SERVICE BULLETIN

No.**292 73 2195**

ARRIEL 2 B - B1 - B1A - C - C-PM - C1 - C2 - C2-CG - D - E - N - S1 - S2

Subject: Fuel system. Modification to the pressurizing valve seal of the adjusted valve assembly.

Figure 1

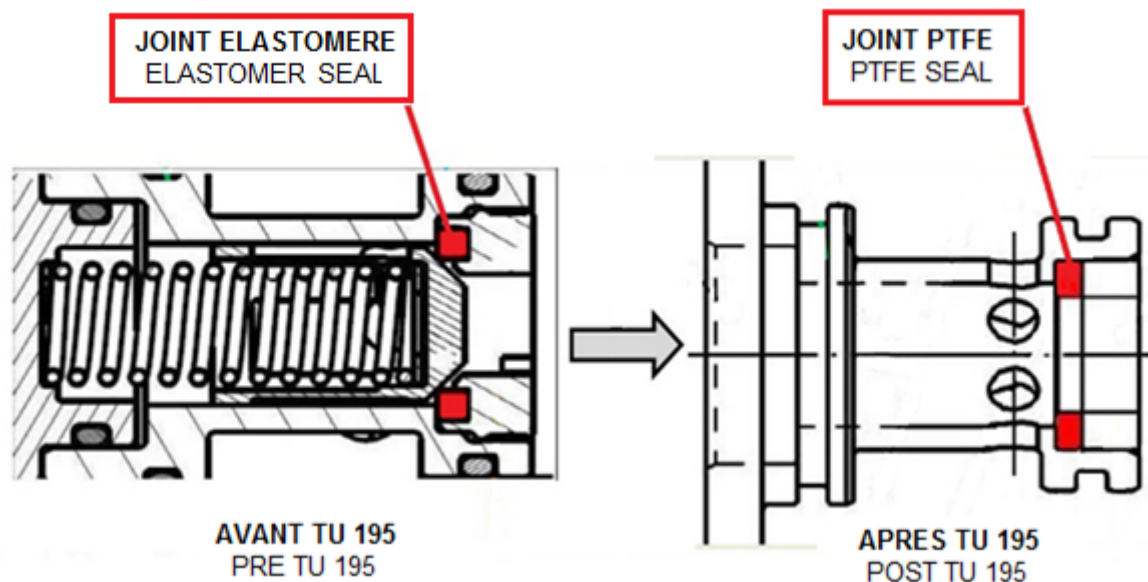
1.3. Description (see Figure 1)

Modification TU 195 replaces the elastomer seal with a PTFE seal. This elastomer seal is installed in the sleeve assy and makes the sealing of the pressurizing valve.

The PTFE seal, which is harder than the elastomer seal, prevents distortion, wear and rupture phenomena. It gives a better resistance to stress.
